Subject: Conduit Support Walkdown Questions
Comanche Peak Steam Electric Station
Independent Assessment Program - Phase 4
Texas Utilities Generating Company
Job No. 84056

CONDUIT WALKDOWN QUESTIONS

Conduit Support Walkdown Checklist

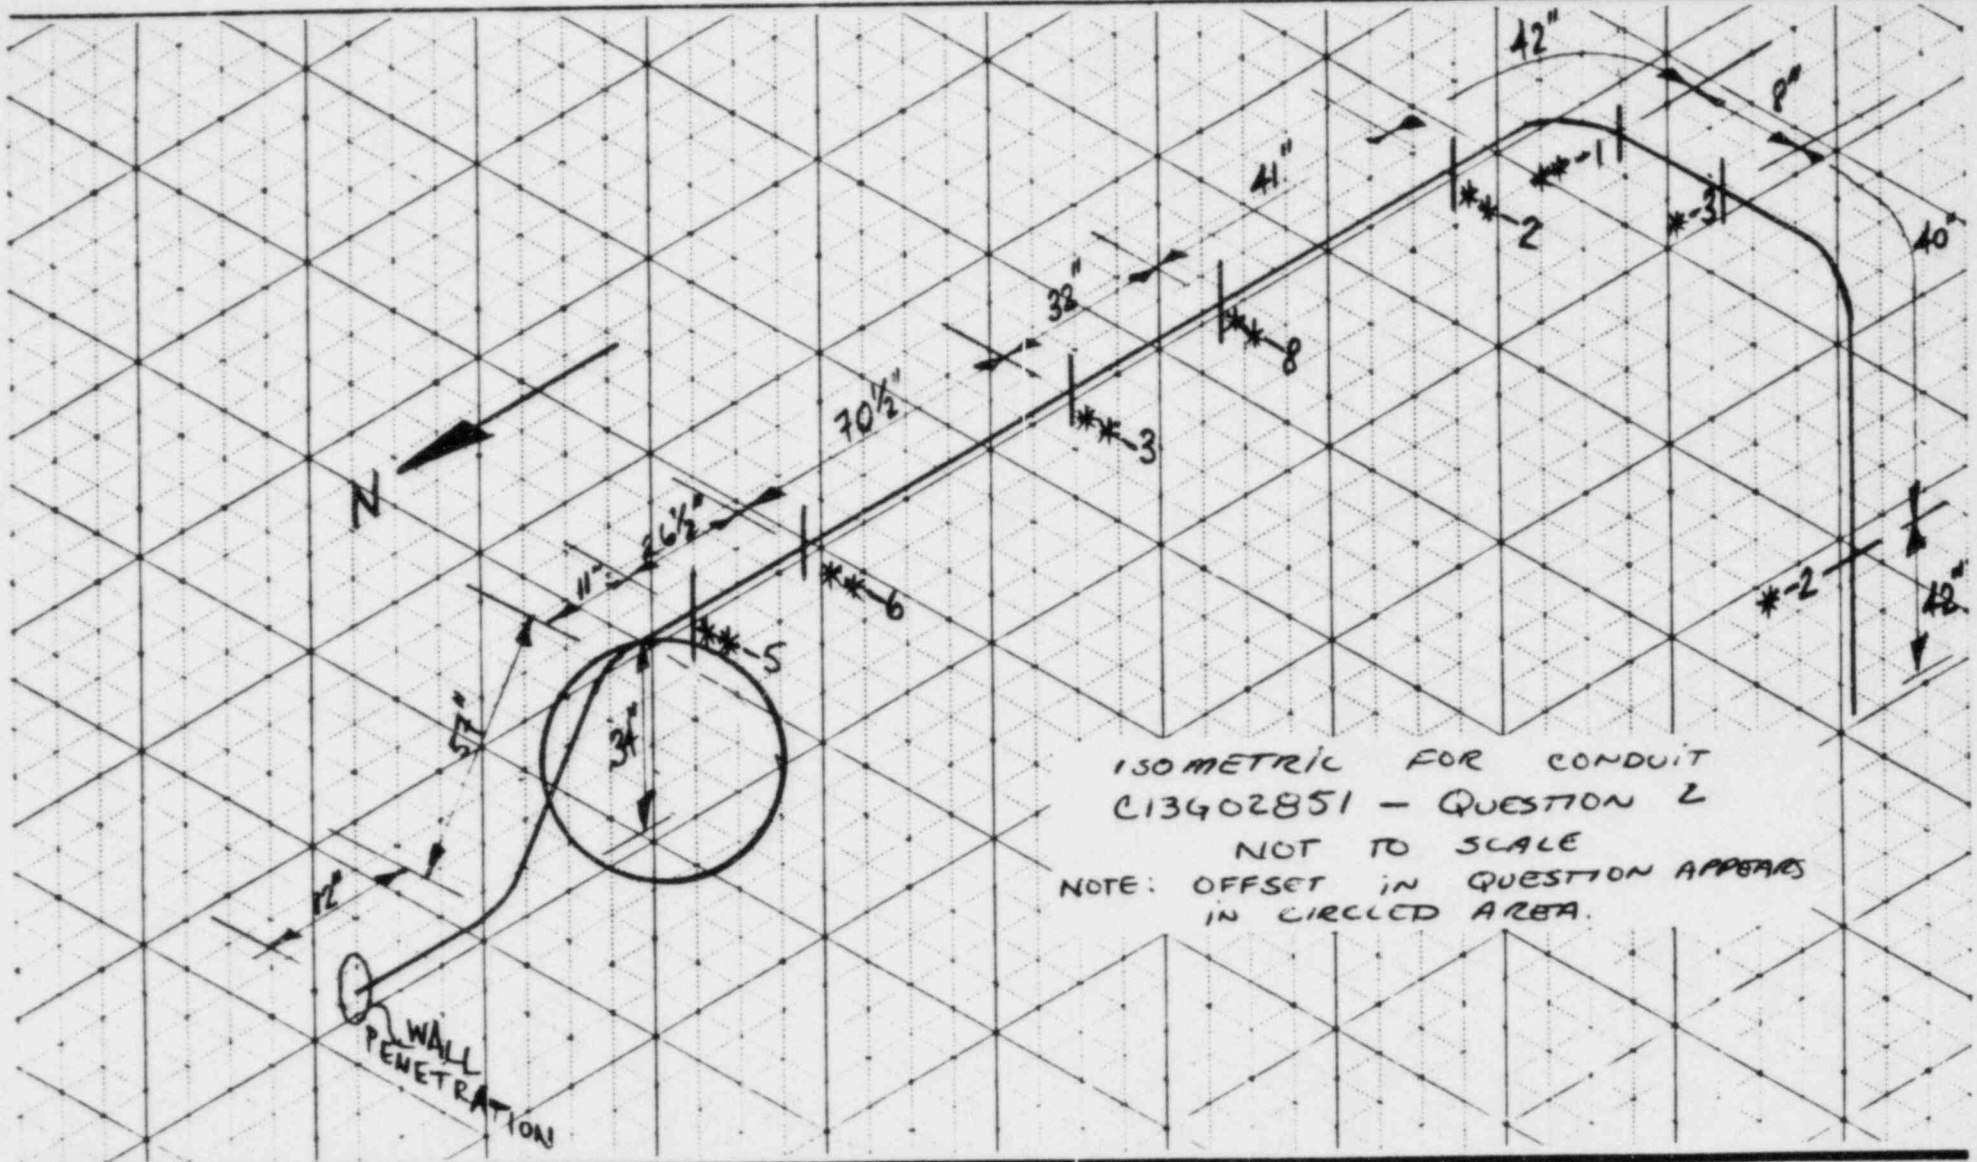
2. Conduit C12G02851 contains an S_3 offset of 2'-10". The allowable S_3 offset for a 1" diameter conduit per drawing 2323-S-0910, p. 6, sht 2, revision 8 is 2'-3". (See Cygna isometric sheet, attached).

Please provide Cygna with justification for allowing an offset dimension of $S_3 = 2'-10"$ for conduit C12G02851 which exceeds the allowable of $S_3 = 2'-3"$.

DEFORMED CONDUIT CLAMP
FOR CSD-5a TYPE
CONDUIT SUPPORT

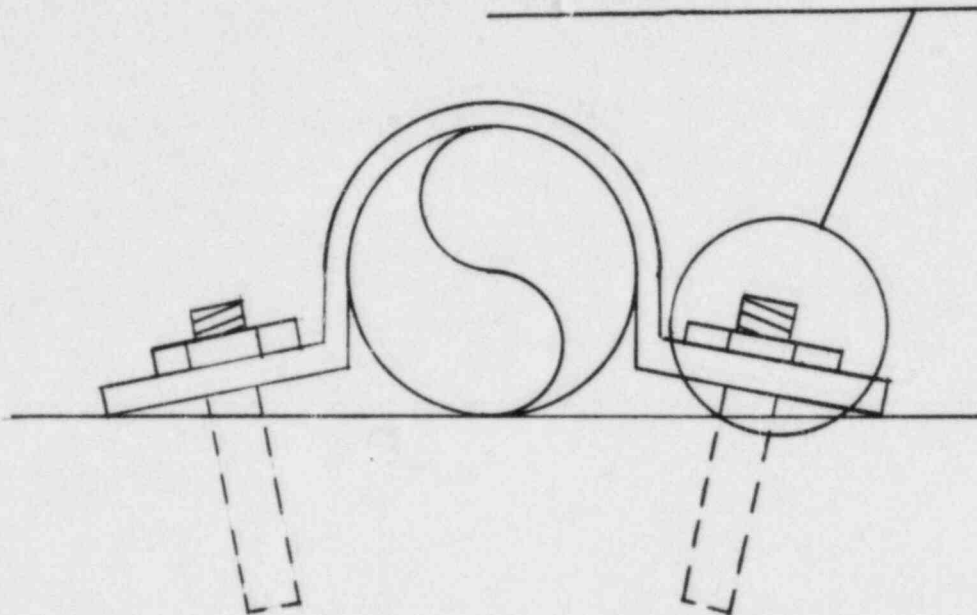
3. Conduit supports C12G02851-6 and C12002935-3 are type CA-5a supports. Cygna's walkdown noted that the conduit clamps were severely deformed in their installed position. As indicated by the attached sketch, even with the clamp deformation, expansion anchor nuts and washers were in full bearing against the clamp, indicating that the anchors were installed at angles to the perpendicular to the concrete surface.

Please provide Cygna with documentation which addresses the acceptability of deformed clamps as described above.

PLAN VIEW OF
SUPPORT C11 Ø 04359-1
TYPE IN-CSM-15u

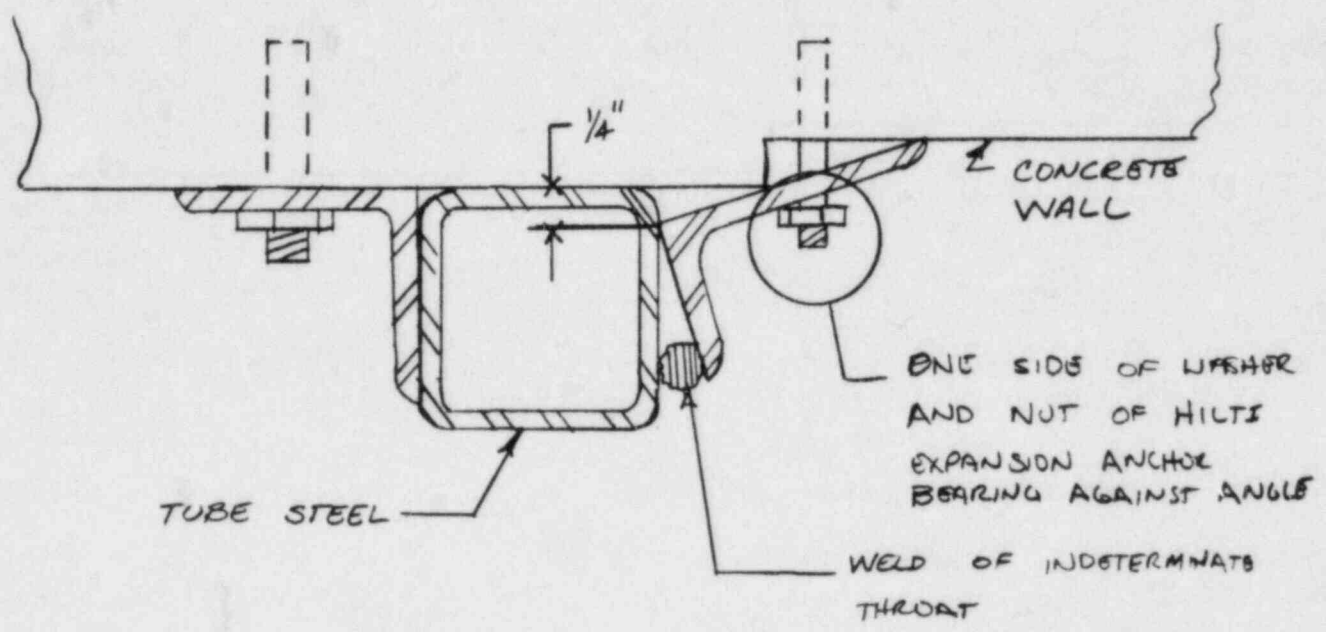
4. For support C11004359-1, type IN-CSM-15a, Cygna's walkdown noted the installed configuration appears as shown in the attached sketch. Due to an irregular concrete surface, the leg of the right angle is not flush against the tube steel section but is rotated such that the tip of the other leg is in bearing against the concrete.

The installed configuration impacts the functional capacity of the support in the following fashion:

- a. The bearing area required for proper load transfer at the support concrete interface may not exist which would result in concrete stresses greater than allowables.

- b. With the angle rotated as shown, only one side of the Hilti expansion anchor is in bearing against the angle. Such a configuration results in the introduction of bending stresses within the bolt which have not been considered in the design.
- c. Due to the rotation of the angles, it would not be possible to place the groove welds between the tube and the angle as shown on the support drawing.

Please provide Cygna with justification for QC acceptance of the base angle installation for support C11004359-1.
